DART AEROSPACE LTD HAWKESBURY, ONTARIO, CANADA	
DRAWING NO. D206-667-247	REV. A SHEET 1 OF 4
TITLE CROSSTUBE ASSY (206L MID AFT)	SCALE NTS

DRAWING NO. D206-667-247	TITLE CROSSTUBE ASS'Y (206L MID AFT)	REV. A	DART AEROSPACE LTD ENGINEERING ORDER		D.E.O. NO. D206-667-247-A-1	SHEET NO. SHEET 1 OF 1	SCALE NTS
DRAWN <i>qp</i>	CHECKED <i>ASS</i>	MFG. APPR. <i>KB</i>	APPROVED <i>IMP</i>		DE APPR. <i>#</i>		
DATE 11.07.15	DATE 11.07.20	DATE 11.07.21	DATE 11/07/21		DATE 11.07.21

REPLACE MAGNOBOND WITH PROSEAL.

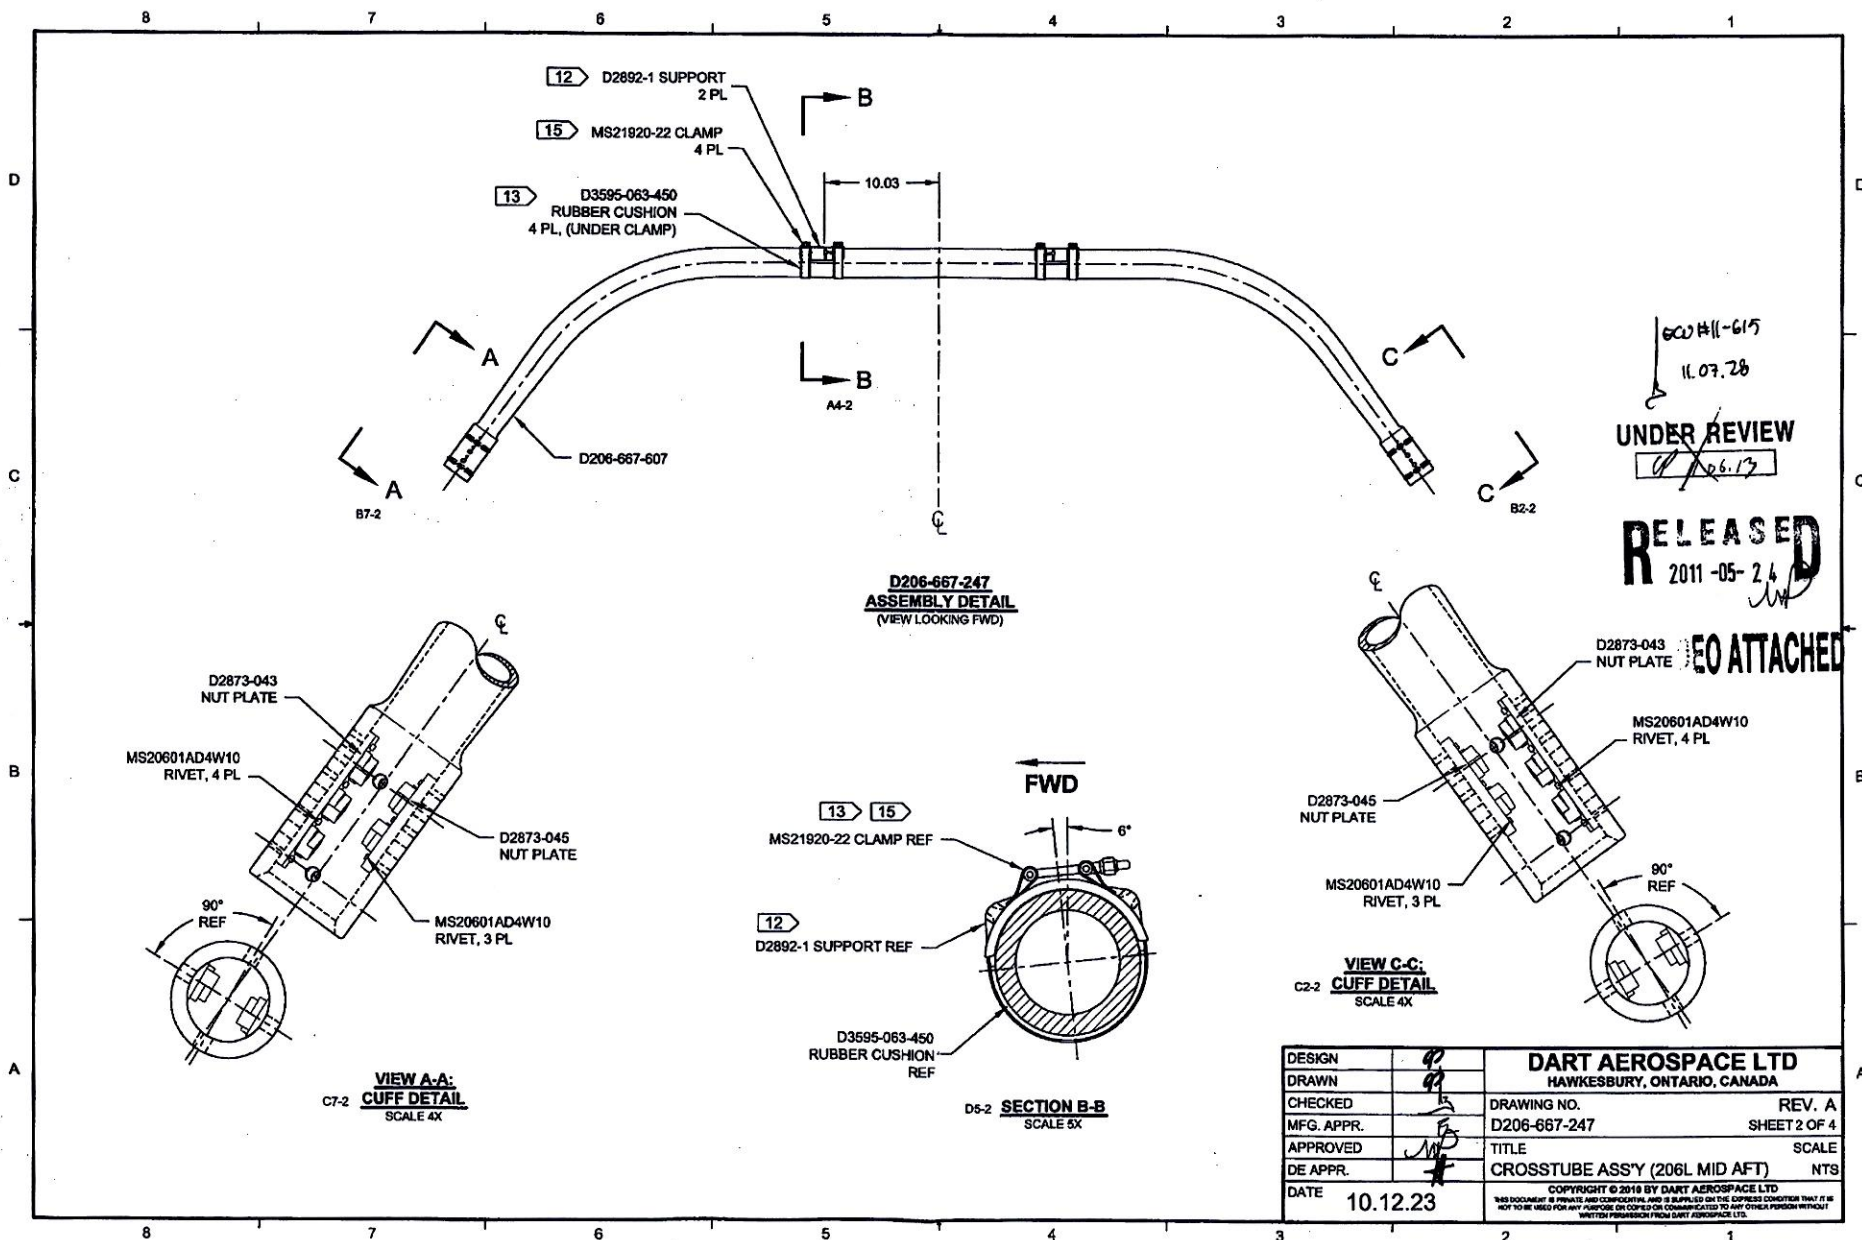
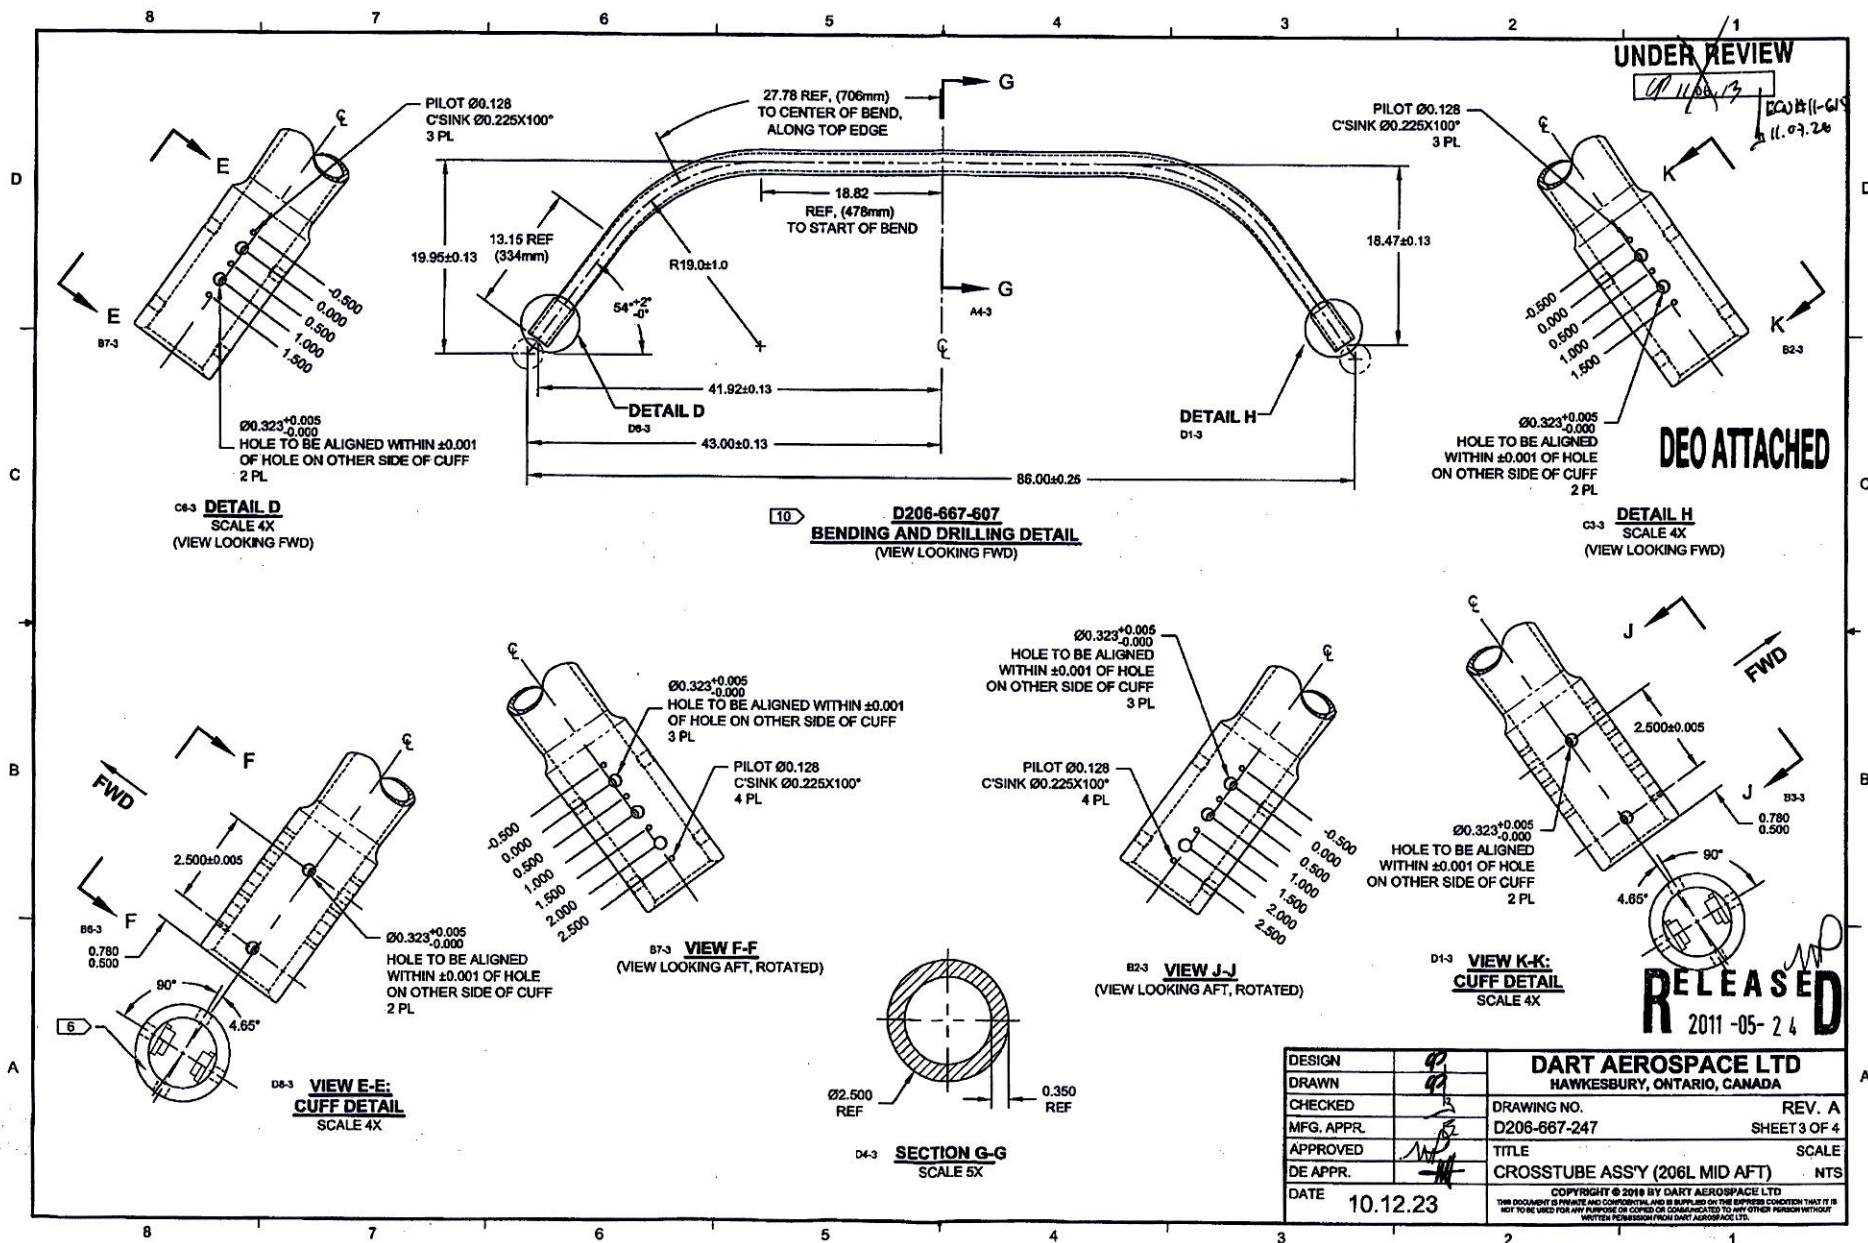
PURPOSE:

CHANGE:

NOTE 12 & 15, SHEET 1 IS AMENDED AS FOLLOWS:

WAS:

- 12) INSTALL D2892-1 SUPPORT USING 0.03" TO 0.06" THICK LAYER OF MAGNOBOND 6398 PER QSI 015. LET CURE FOR 12 HOURS AFTER INSTALLATION AND PRIOR TO PACKAGING.
- 15) TORQUE CLAMPS 80 TO 100 IN-LB. ENSURE AT LEAST 1.5 THREADS SHOWING IN SAFETY AND THAT NUT HAS NOT BOTTOMED-OUT AFTER TORQUING.

IS:

Item	Qty -247	Part Number	Description
9	A/R	PROSEAL 890 B-2	SEALANT, AMS-S-8802 CLASS B-2

IS:

- 12) TO INSTALL D2892-1 SUPPORT: ABRASE MATING SURFACE OF SUPPORT AND CROSSTUBE WITH 180-GRIT SANDPAPER AND REMOVE RESIDUE WITH MEK (OR EQUIVALENT). APPLY A 0.04" TO 0.07" THICK LAYER OF PROSEAL 890 CLASS B-2 (OR AMS-S-8802 CLASS B-2) SEALANT TO MATING SURFACE OF SUPPORT.
- 15) TORQUE CLAMPS 80 TO 100 IN-LB. ENSURE AT LEAST 1.5 THREADS SHOWING IN SAFETY AND THAT NUT HAS NOT BOTTOMED-OUT AFTER TORQUING. **PRIOR TO PACKAGING, RE-CHECK TORQUE ON CLAMPS AFTER PROSEAL 890 SEALANT HAS CURED FOR 72 HOURS.**
